ECE/TRANS/WP.29/GRSG/74
19 November 2008

Working Party on General Safety Provisions

**REPORT OF THE WORKING PARTY ON GENERAL SAFETY PROVISIONS
ON ITS NINETY-FIFTH SESSION
(Geneva, 21 to 24 October 2008)**

" Figure 7
FORWARD LIMITATION OF THE GANGWAY
(see Annex 3, paragraph 7.7.5.1.1.1.)

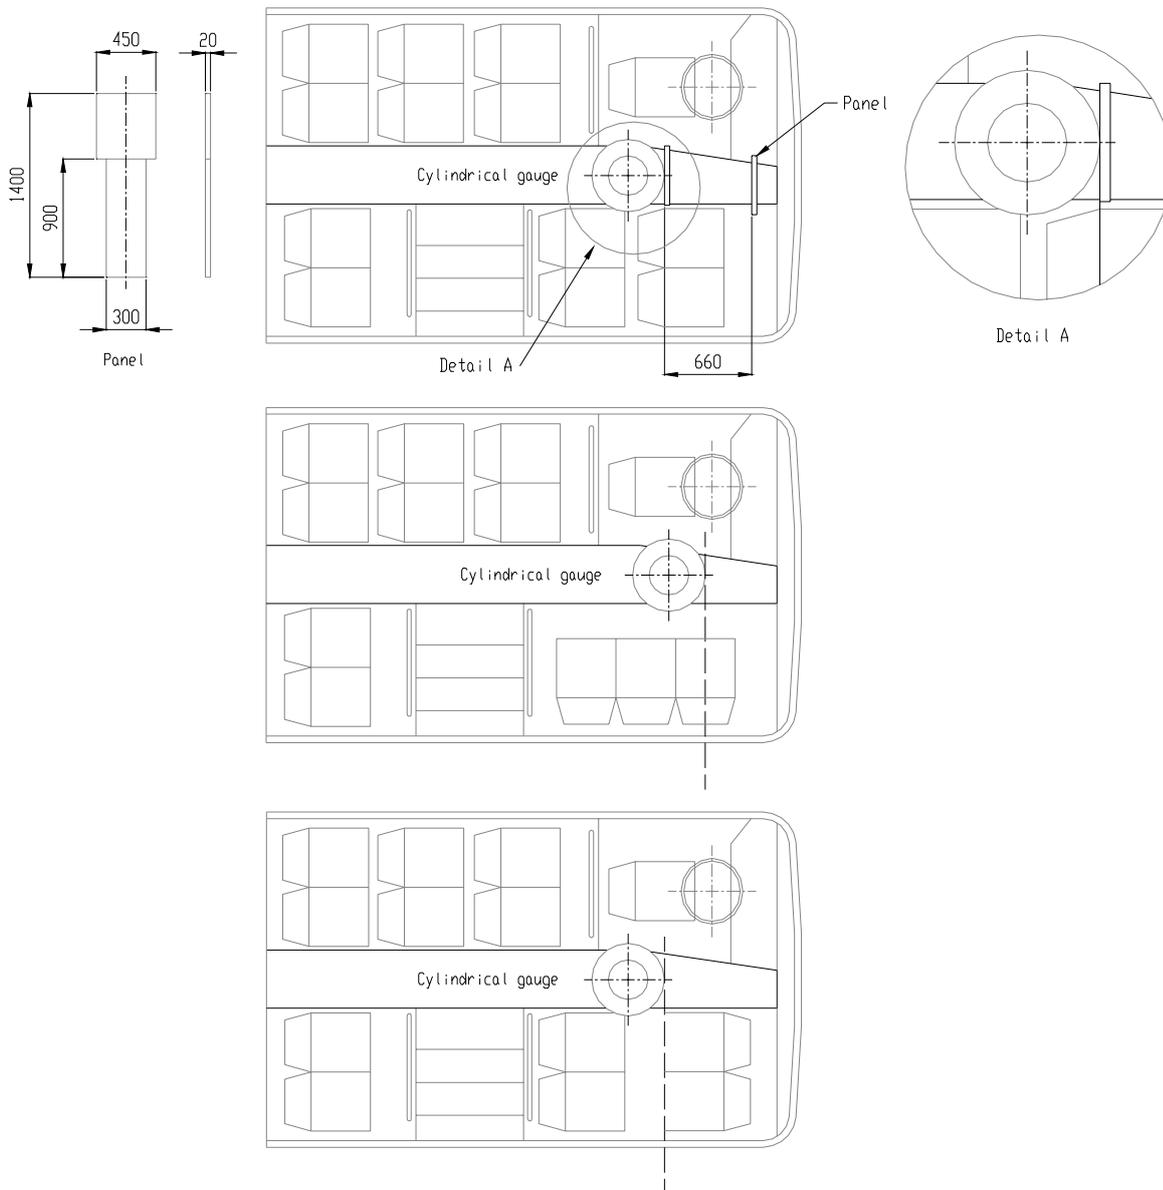
Annex 4, Figure 7, amend to read:

"Laminated glass panels other than windscreens

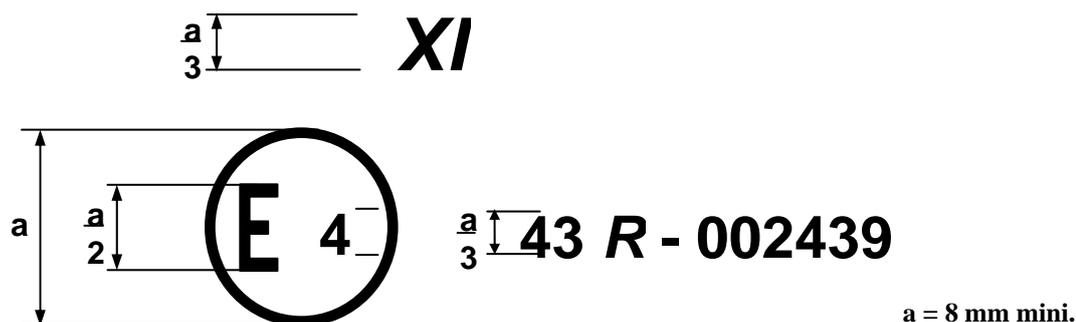
Add the following approval mark examples, to read:

The above approval mark affixed to a laminated glass pane other than a windscreen, shows that the component concerned has been approved in the Netherlands (E 4) pursuant to Regulation No. 43 under approval No. 002439. The approval number indicates that the approval was granted in accordance with the requirements of Regulation No. 43."
